VERMONT
TOWN OF FERRISBURGH
COUNTY OF ADDISON
COMMUTER PARK-AND-RIDE LOT

RECORD PLANS

CONTRACTOR: J.A. McDONALD - LYNDON, CTR., VT.

PROJECT NAME:	FERRISBURGH/VERGS-FERRISBURGH
PROJECT NUMBER:	CMG PARK (15)S/STP EHO(21)
FILE NAME:	...Highway\PlotFiles\50water.p
PROJECT LEADER:	WLD
DESIGNED BY:	BFR
DRAWN BY:	JSK
CHECKED BY:	JTM
WATER LINE PLAN	
SHEET 50	OF 65

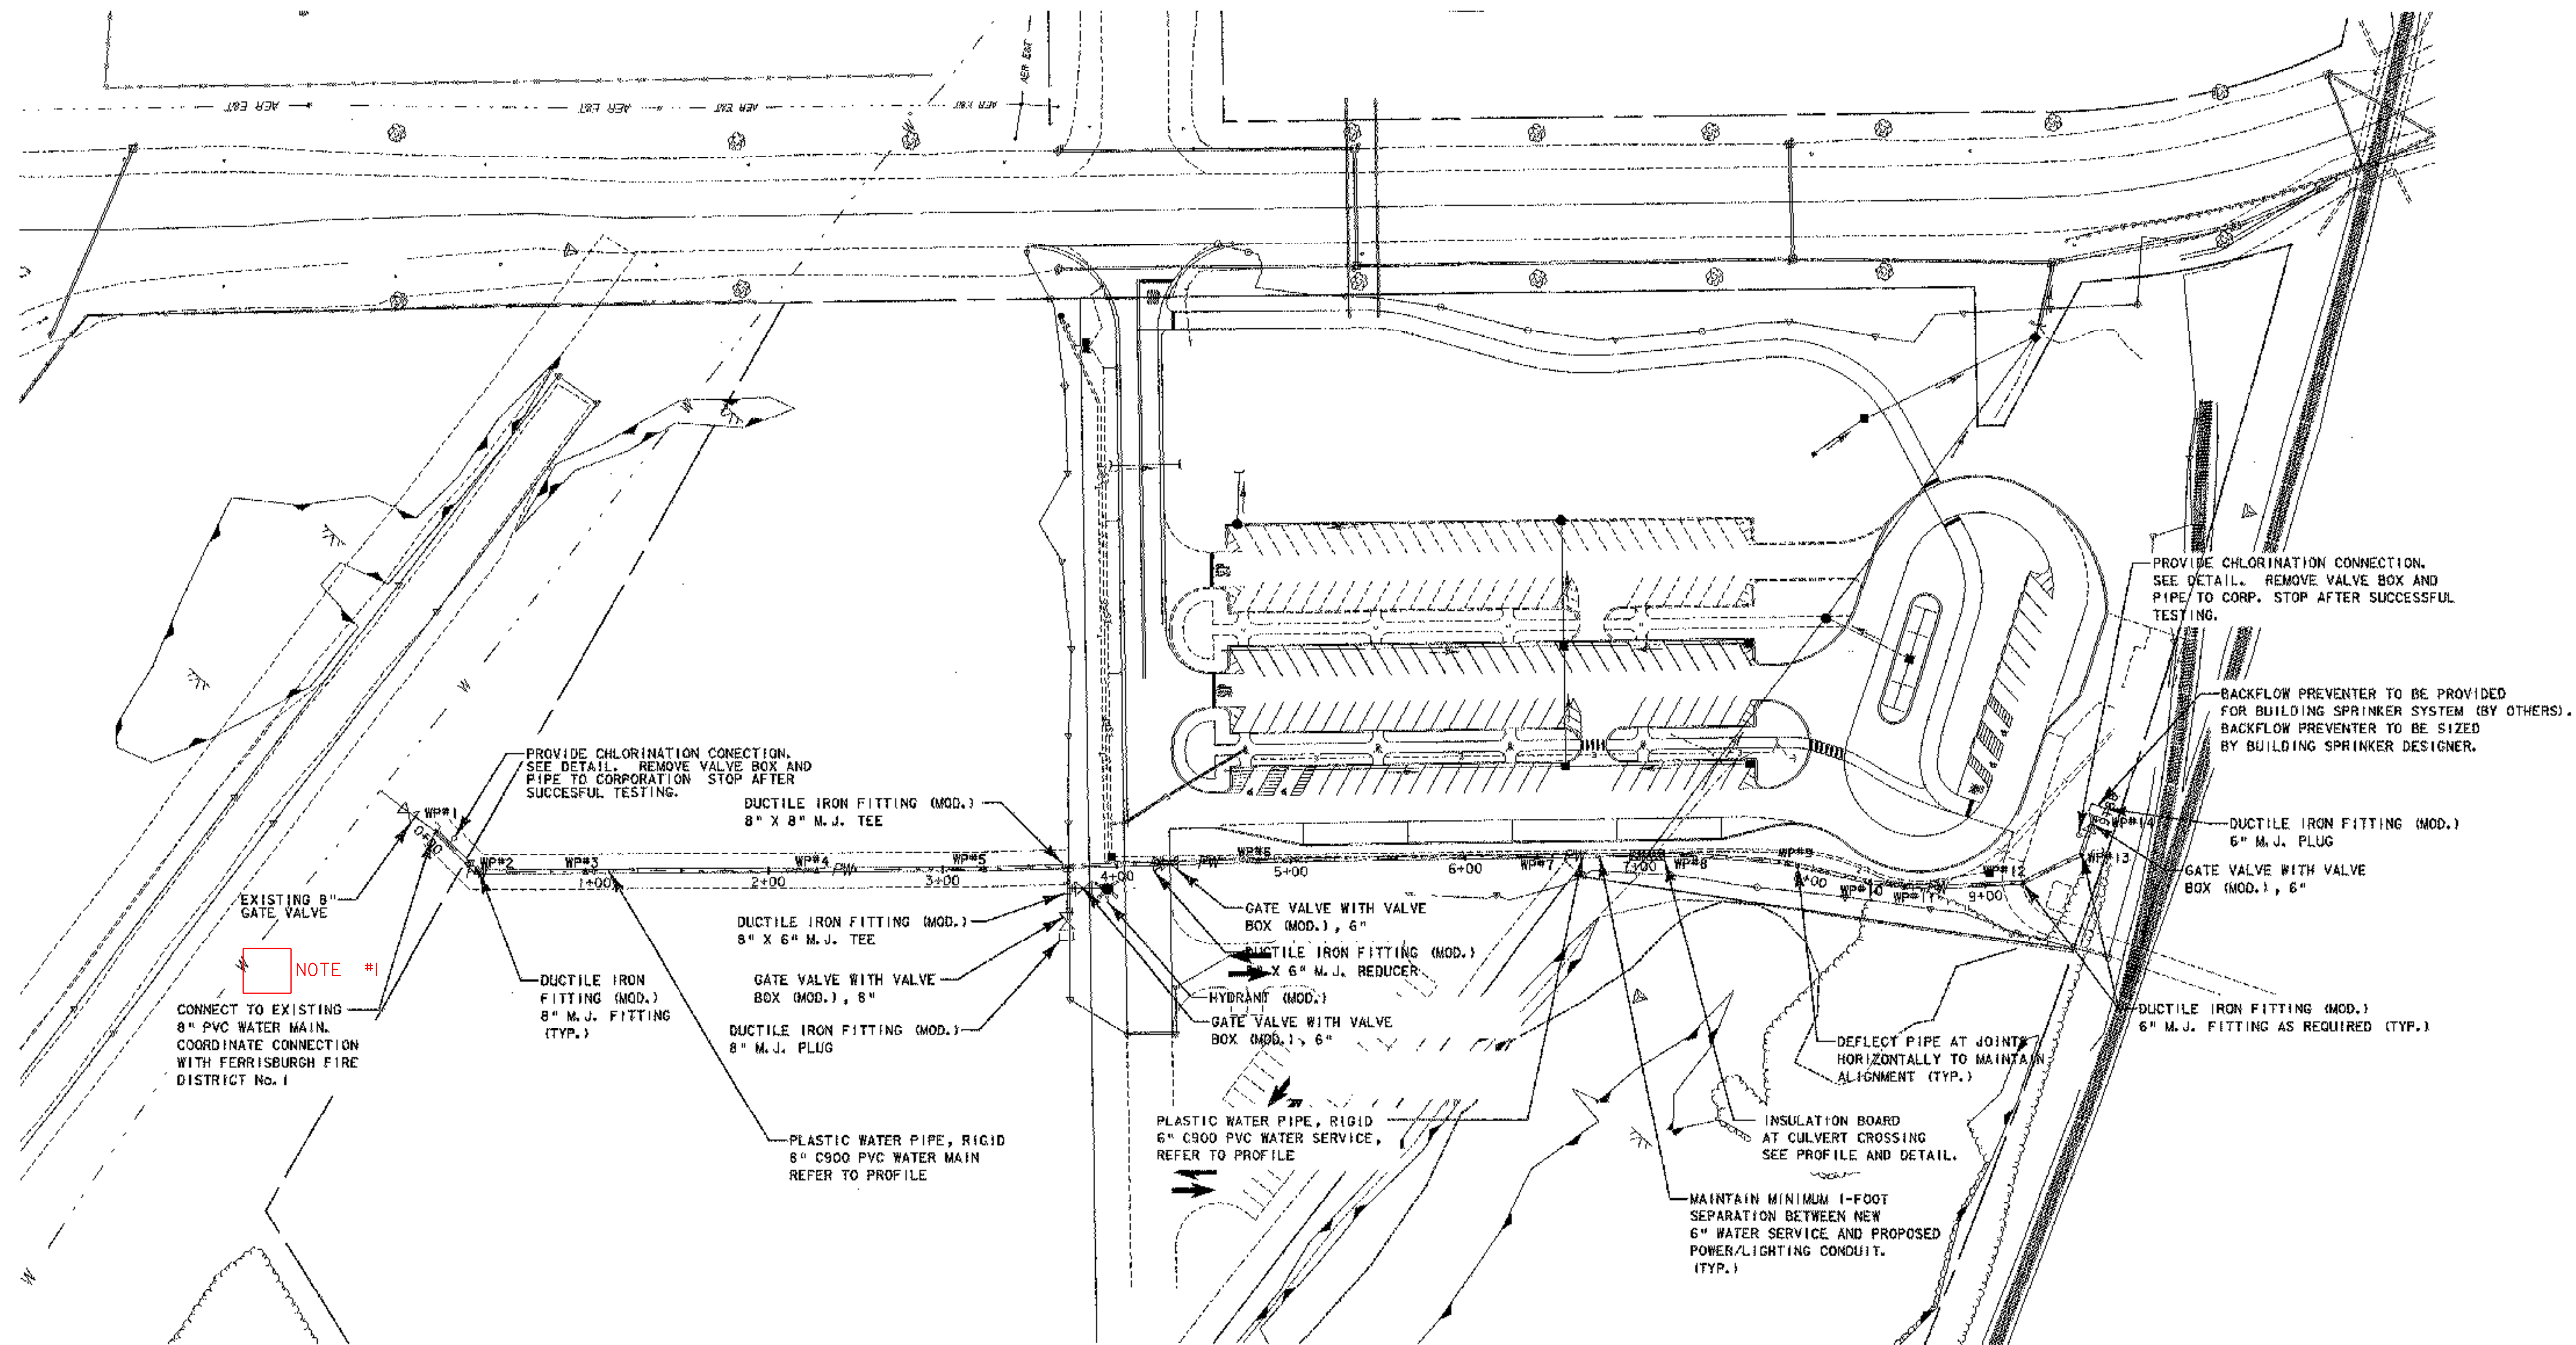
NOTE #1: UNABLE TO LOCATE ALLEGED STUB AS DRAWN. STANTEC PROVIDED ADD'L INFO ON 10/23/06 TO LOOK 158.2FT TO THE NORTH OF DESIGN LOCATION, AT THAT APPROX. LOCATION THERE SEEMS TO BE AN AIR BLOW OFF. DRN 10/24/06
